Proposal Outline planning application for the construction of up to 140,000 sqm of employment floorspace (use class B8) with ancillary offices and facilities and servicing and infrastructure including new site accesses. Internal roads and footpaths, landscaping including earthworks to create development platforms and bunds, drainage features and other associated works including demolition of the existing farmhouse.

Location Land east of Junction J.11, M40, Banbury

Application No. 23/03428/OUT

Following submission of the Flood Risk Assessment and Drainage Strategy (FRA & DS) produced by Delta-Simons (dated May 2022 Project No: 21-2141.01), the LLFA response was included with Oxfordshire County Council composite response dated 12th of February 2024, the LLFA objected to the development. The detailed comments from the LLFA are reproduced and Mabbett's responses on behalf of the applicant are below.

Drawing
**Conceptual Drainage Sketch
Catchment B Area**

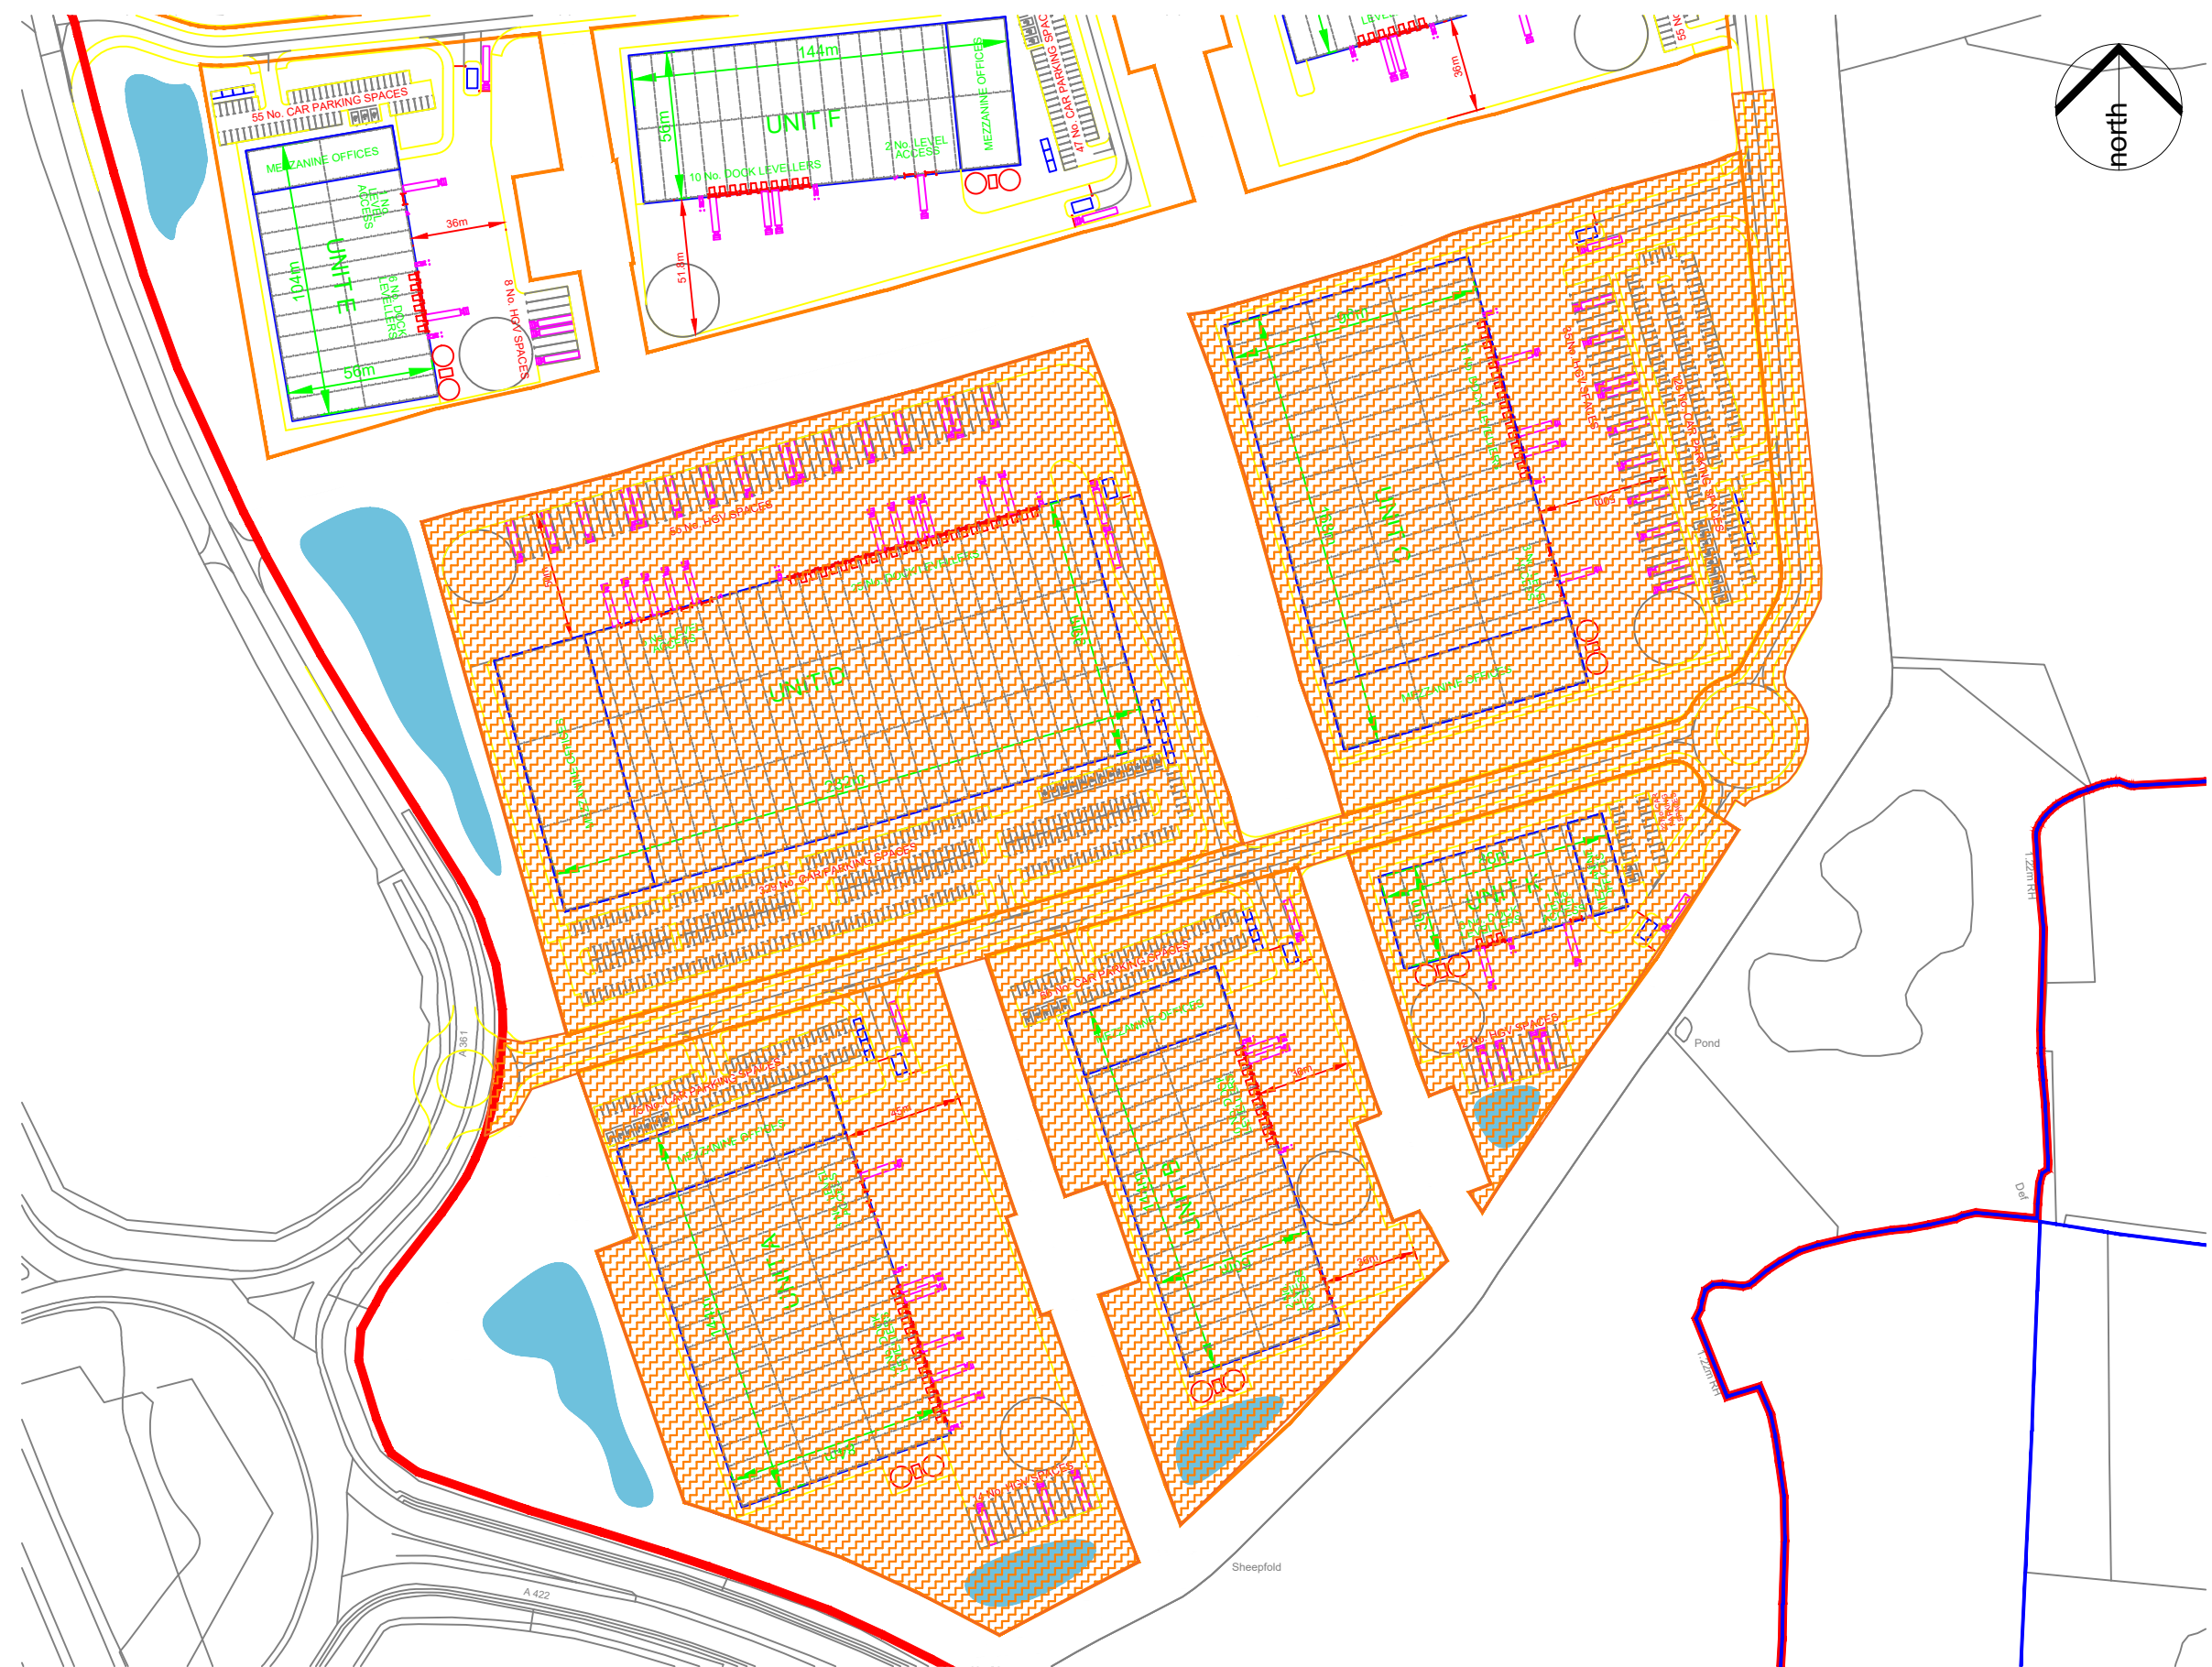
“The catchment areas have been broken down in the FRA, however a Catchment plan is required to highlight the extent of the areas. Stating the total impermeable area and the impermeable area including urban creep”.

A Catchment Plan is included in Appendix B of this letter.

The site can be split into two catchments each served by the two existing culverts at the lowest extents of the site. The site can be further split into individual plot catchments at the detailed design stage if required. It is reiterated that the layout is not fixed, and the catchment areas may change as a result of works undertaken at the detailed stage.

Area (m ²)	Discharge Rate (l/s)
Catchment A	143,060	206.9
Catchment B	175,287	253.56

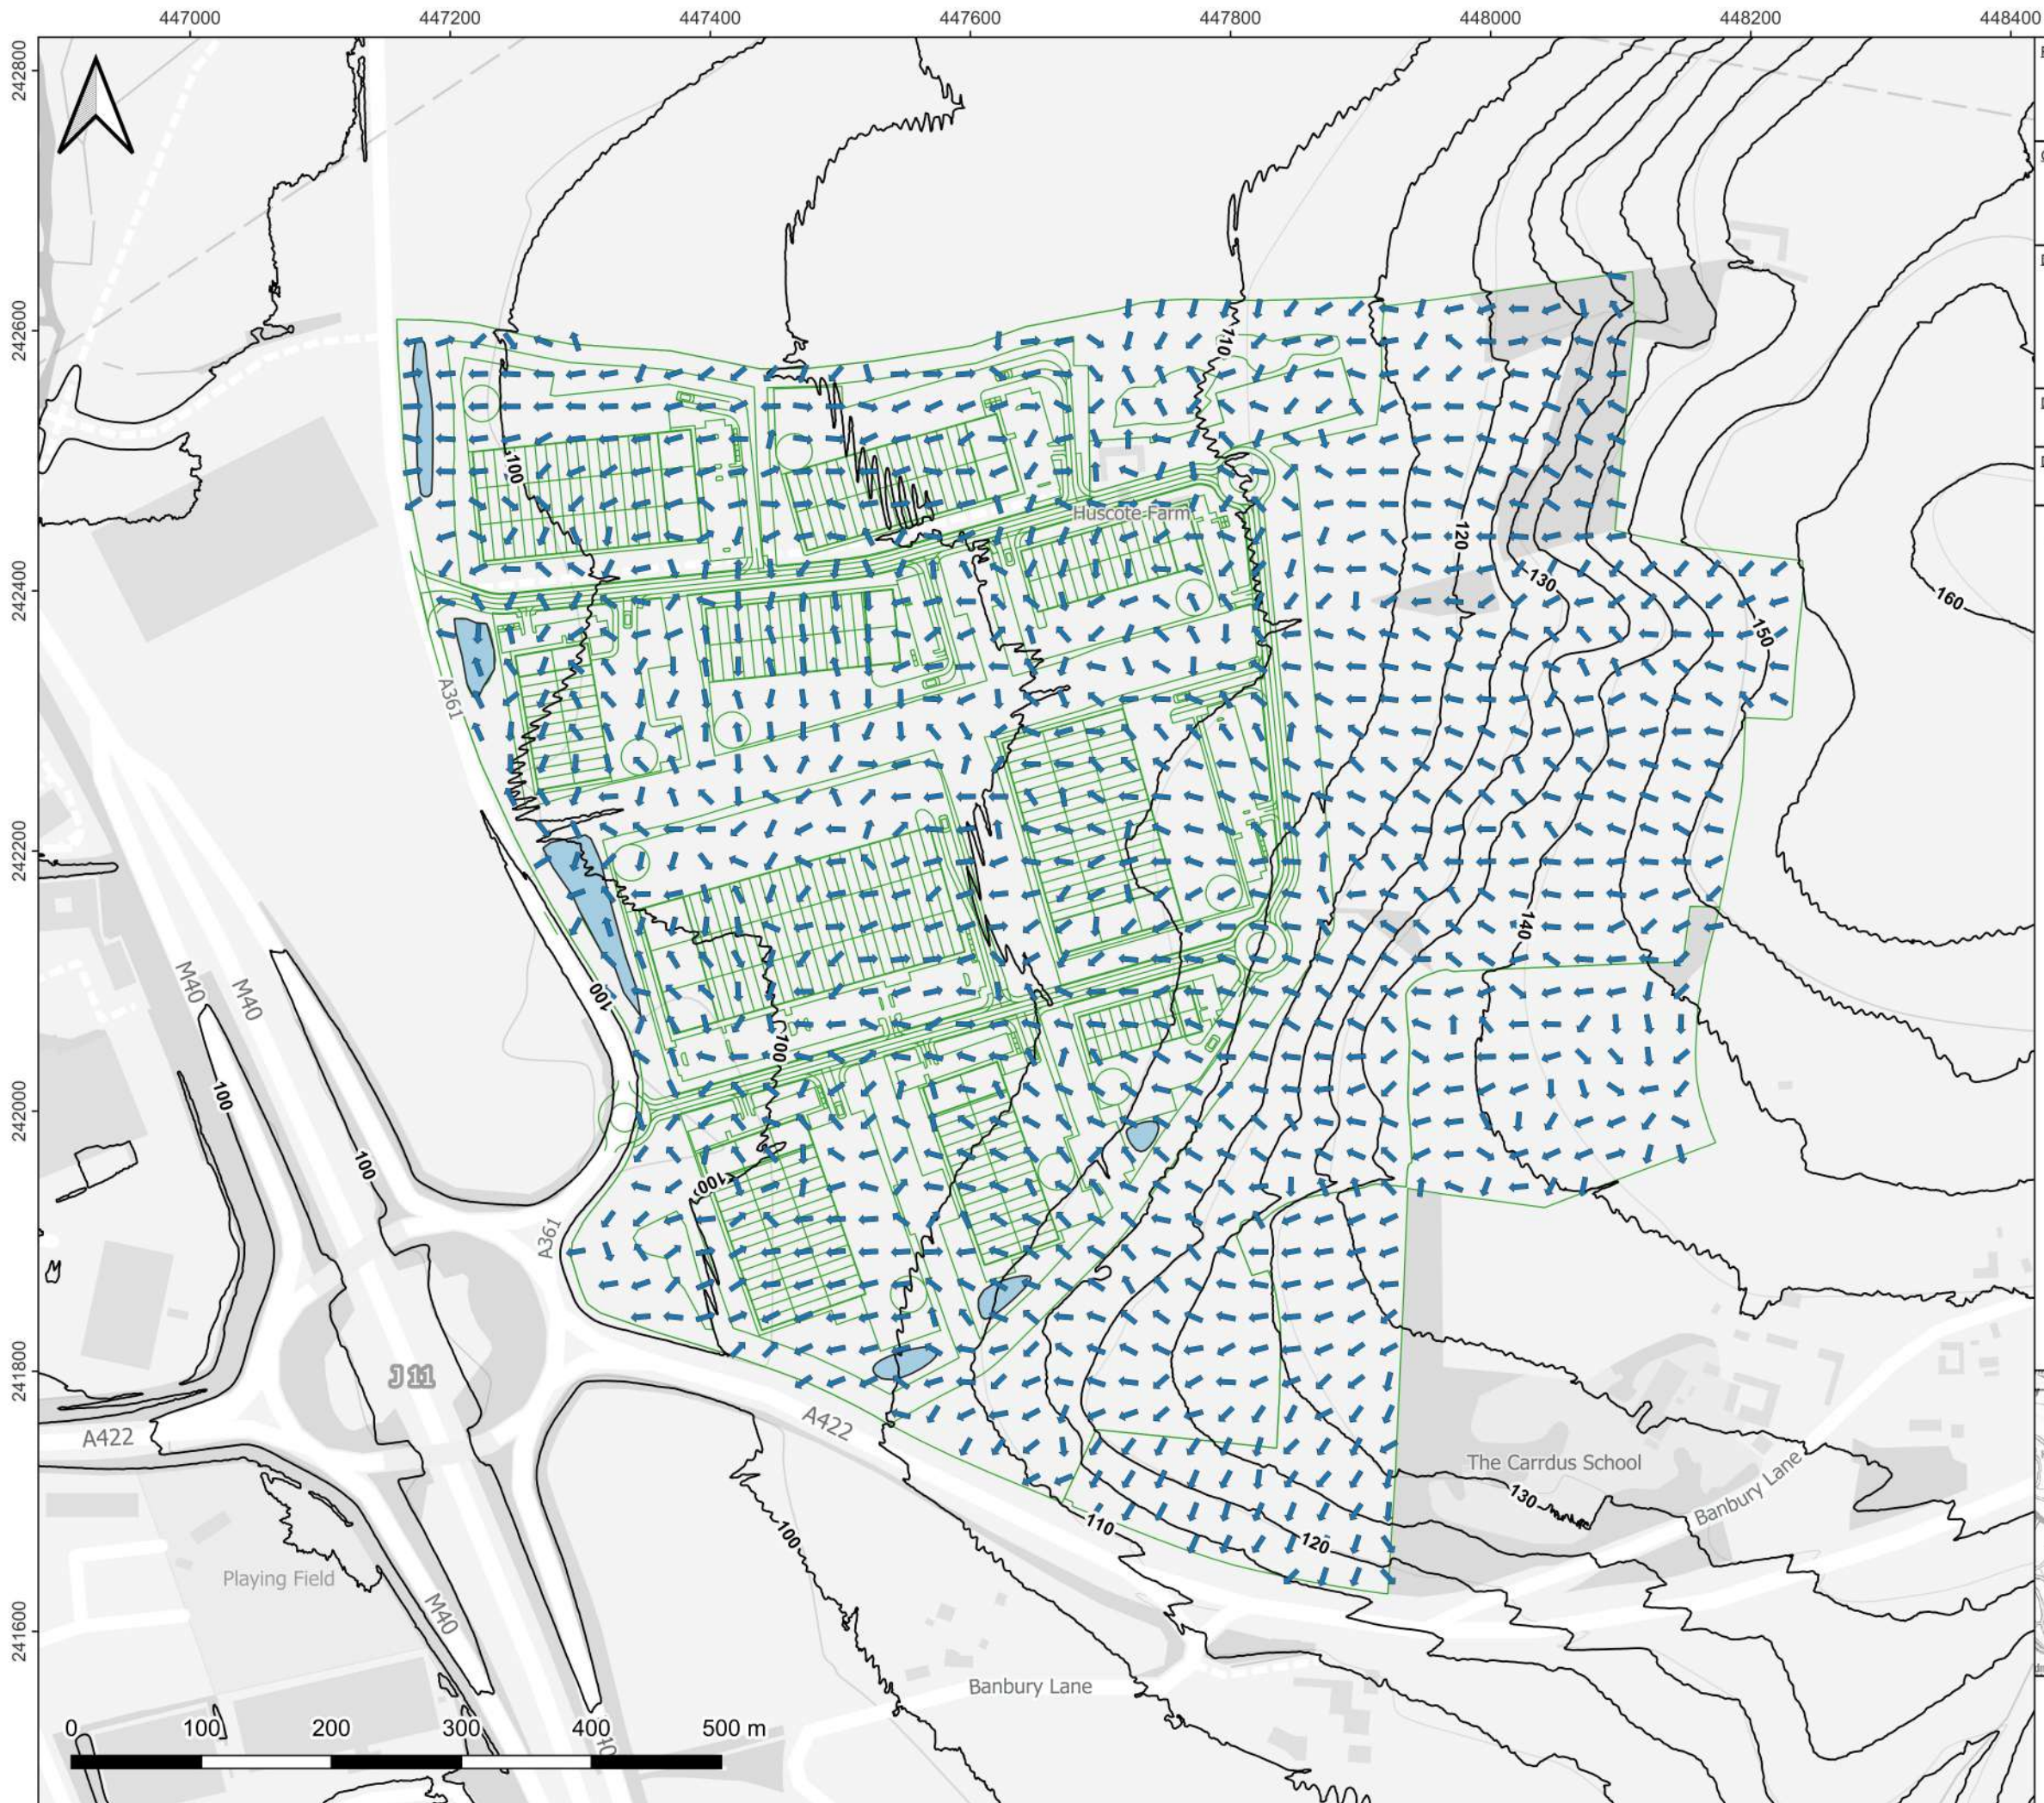
Surface water exceedance flow plans required to demonstrate how the site is draining to ensure all surface water is being picked up by the proposed drainage infrastructure.

Surface Water Exceedance Flow Plan is included as Appendix C of this letter.

The proposed drainage system is proposed to attenuate the full balance of surface water generated by the site during a 1 in 100 year plus 40 % CC storm at the 1 in 2 year existing greenfield runoff rate (estimated using ReFH2 method). The likelihood of exceedance is therefore, beyond the design event and unlikely to occur. Especially when considering the required freeboard inherent in attenuation pond design.

We have therefore utilised the existing topography of the site to show the potential flow paths throughout the site. The plan shows that in the event of exceedance, surface water will generally flow westward and away from the site.
